TECHNICAL NOTE

Job Name: Pump Farm Lower Rainham
Job No: 44538
Note No: 44538/TN001
Date: January 2020
Prepared By: Iris Kalaci
Subject: Surface Water Drainage Strategy Addendum

2. Executive Summary of Changes

PUMP FARM, LOWER RAINHAM DRAINAGE STRATEGY

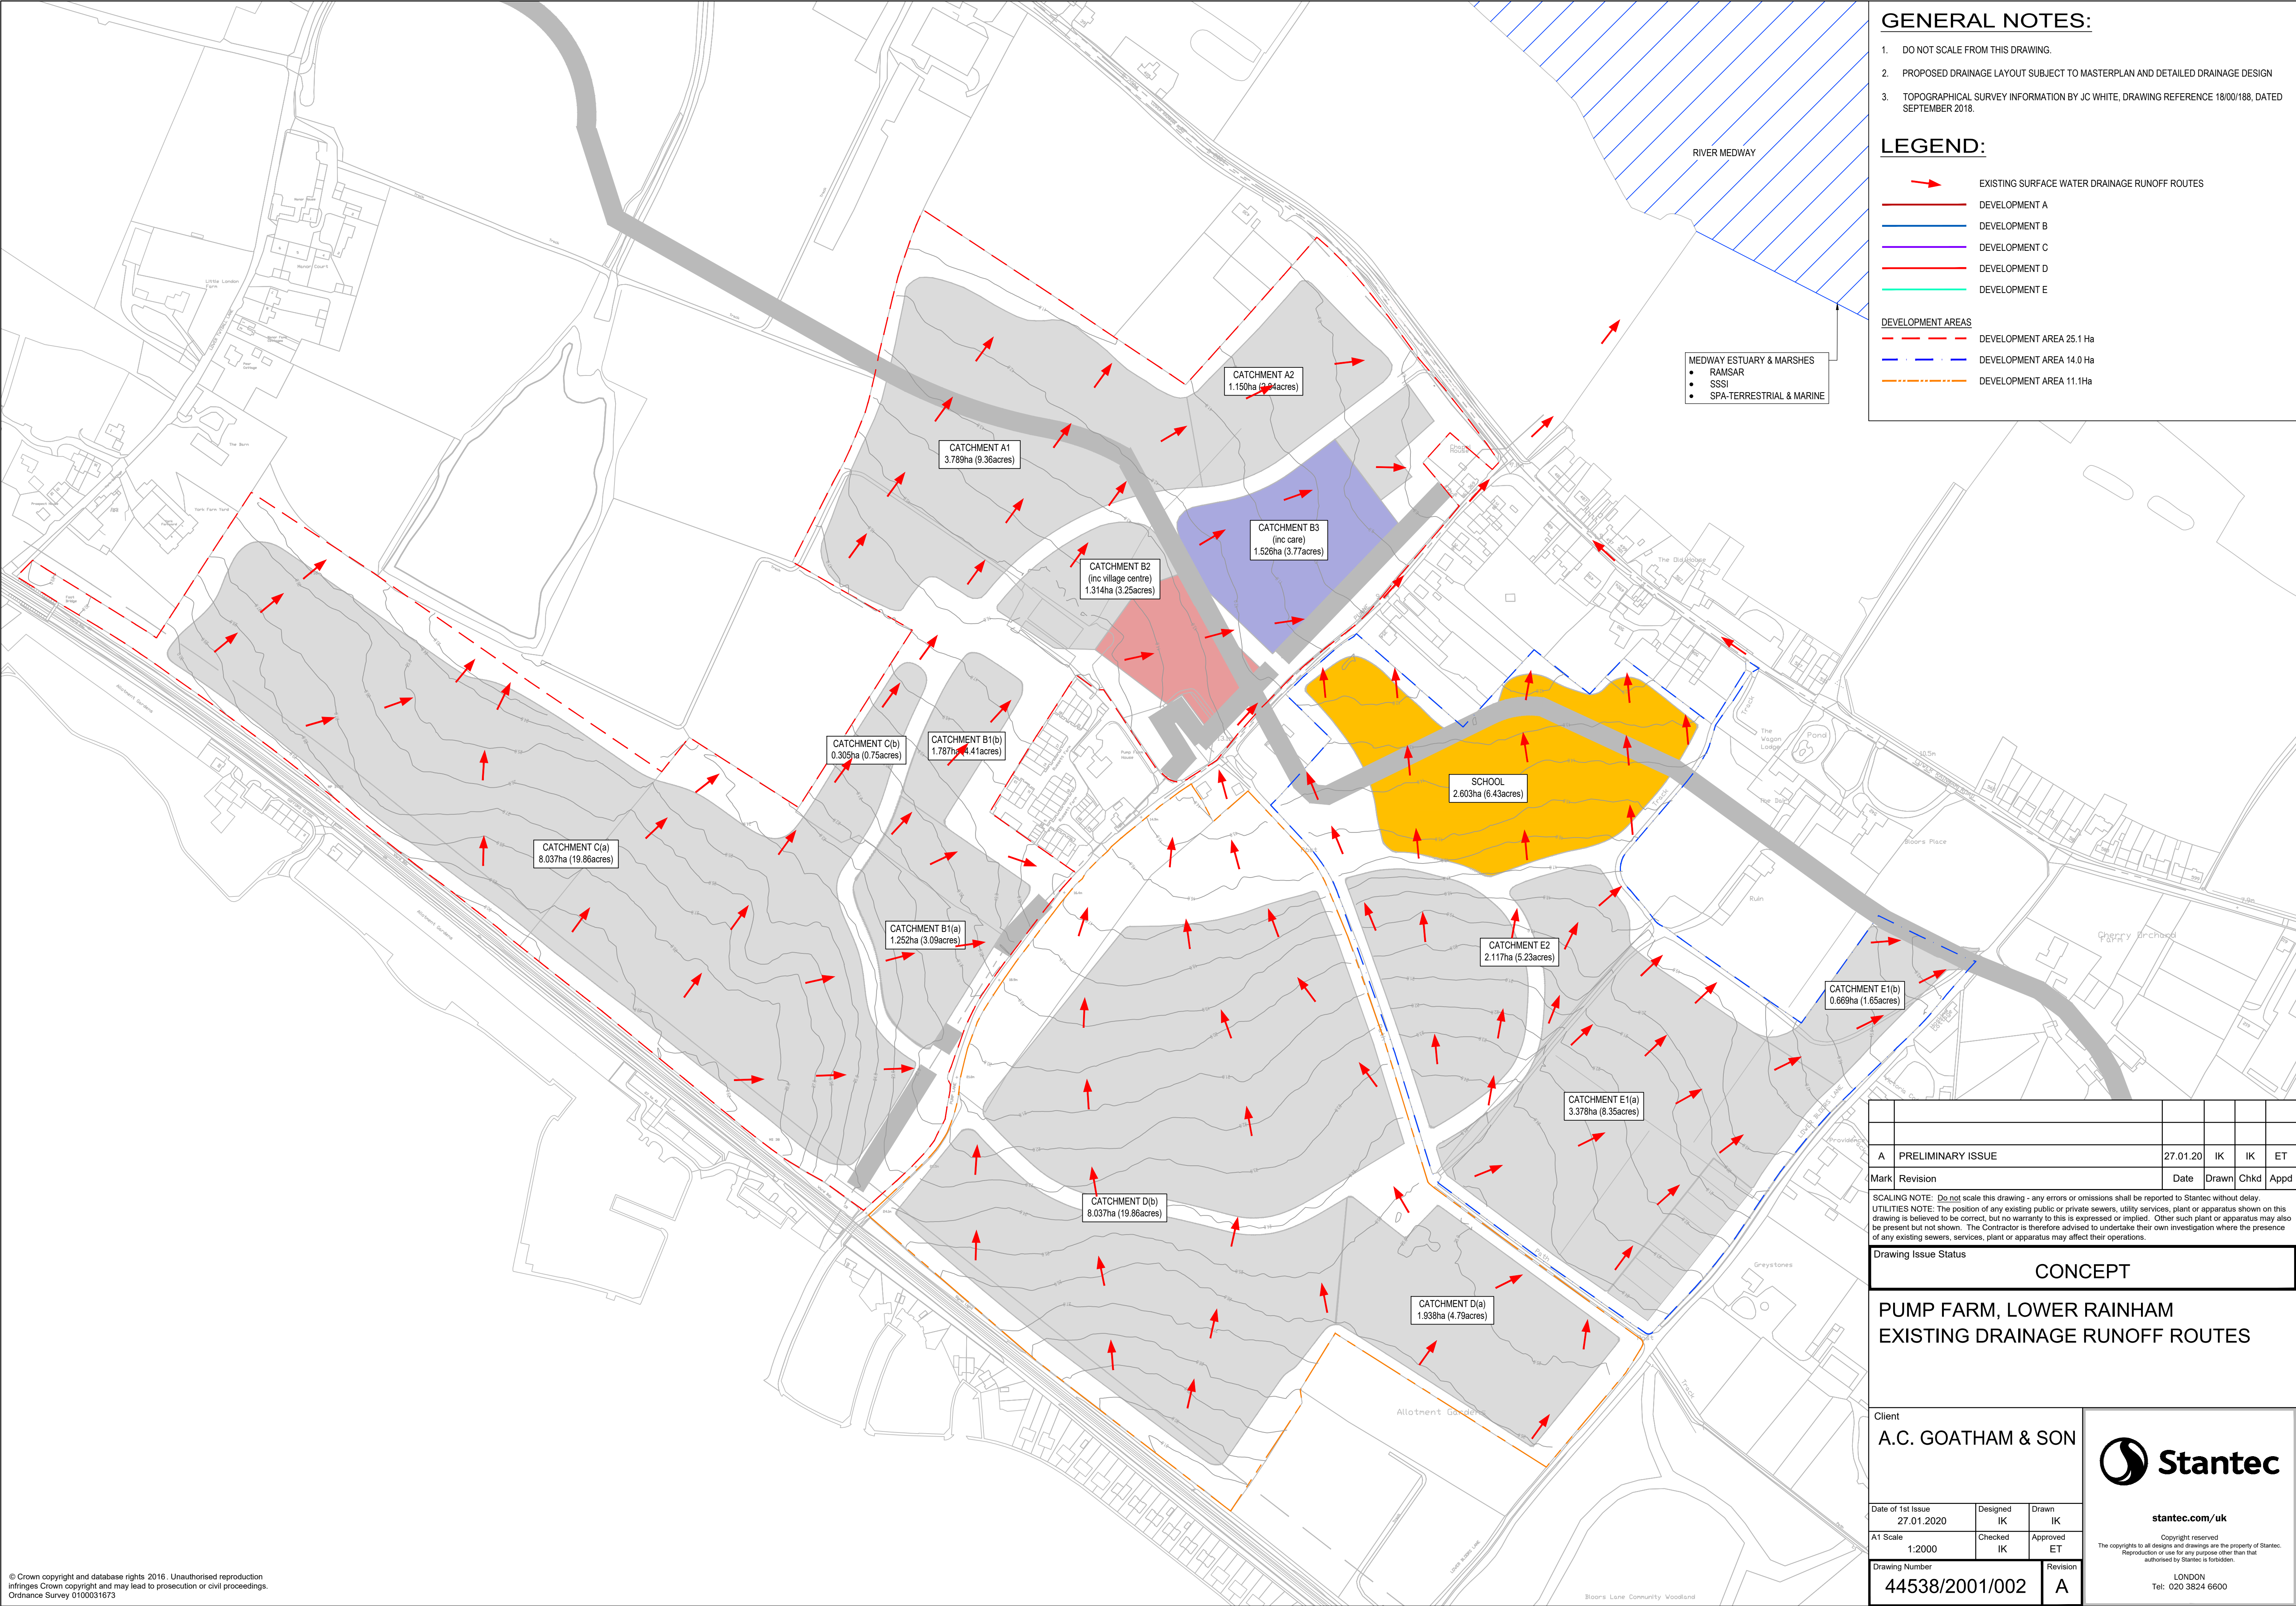
D	SURFACE WATER DRAINAGE SOLUTION CHANGED TO INFILTRATION. SIZE OF BASINS AND NUMBER OF DEEP BORE SOAKAWAYS AMENDED. FILTER DRAINS AND EXCEEDANCE ROUTES ADDED.	27.01.20	IK	IK	ET
C	UPDATED MASTERPLAN	05.12.18	AH	CD	CD
B	SURFACE WATER AREAS UPDATED	12.11.18	AP	CD	CD
A	CONTOUR INFORMATION SHOWN	08.11.18	AP	CD	CD
Mark	Revision	Date	Drawn	Chkd	Appd
